# Office Action Summary

10/068,304

**DETAILED ACTION**

Fig. 7

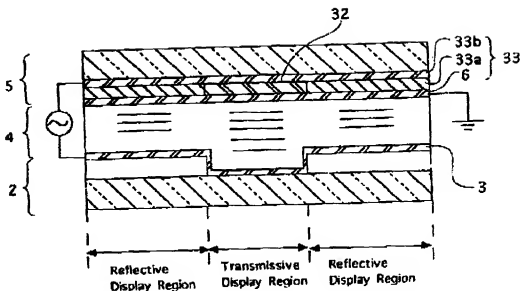
1. **Claims 1-4, 7-9 and 13-18 are rejected under 35 U.S.C. 103(a) as being unpatentable over Kubota et al., (Kubota), US 2002/0171792.**
2. Kubota discloses and shows in Fig. 7, a transfective liquid crystal display device comprising:
- a liquid crystal arranged between first and second substrates;

- a reflective conductive film formed on the first substrate and reflecting light from outside of the second substrate;

- a pixel electrode (3) (applicant's light transmitting metal oxide film) (page 4, paragraph 0055) laminated on the reflective conductive film so that the edge of the metal oxide film is in contact with the first substrate; and

wherein the outer edge of the pixel electrode transmits light from outside the first substrate while the reflective conductive film reflects light from the outside of the second substrate.

As to claim 7, Kubota also shows in Fig. 7 that the reflective conductive film and the metal oxide form a first electrode for applying voltage to the liquid crystal layer.

As to claim 8, Kubota also shows in Fig. 7 that the device further comprising a second electrode (6) formed on the second substrate opposite to the first electrode, and a color layer (33a) provided corresponding to the crossing regions between the first and second electrodes.

As to claim 14, it is clear from Fig. 7 of Kubota that the area of the edge in contact with the first substrate is between 10-70%, preferably 30 to 50% of the area of one display dot to which the edge belongs.

Fig. 8

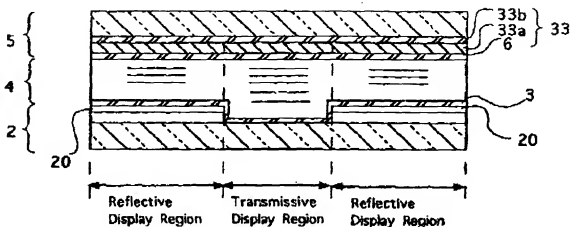
As to claim 2, Kubota shows in Fig 8, a transfective liquid crystal display device comprising:

- an underlying layer provided on the first substrate;
- a reflective conductive film (20) formed on the underlying film, reflecting light from outside the second substrate;
- a pixel electrode (3) (applicant's light-transmitting metal oxide) film laminated on the reflective conductive film (20) so that the edge of the metal oxide film (3) is in contact with the underlying film;

wherein the outer edge of the metal oxide film transmits light from outside the first substrate.

As to claim 15, it is clear from Fig. 8 of Kubota that the area of the edge in contact with the first substrate is between 10-70%, of the area of one display dot to which the edge belongs.
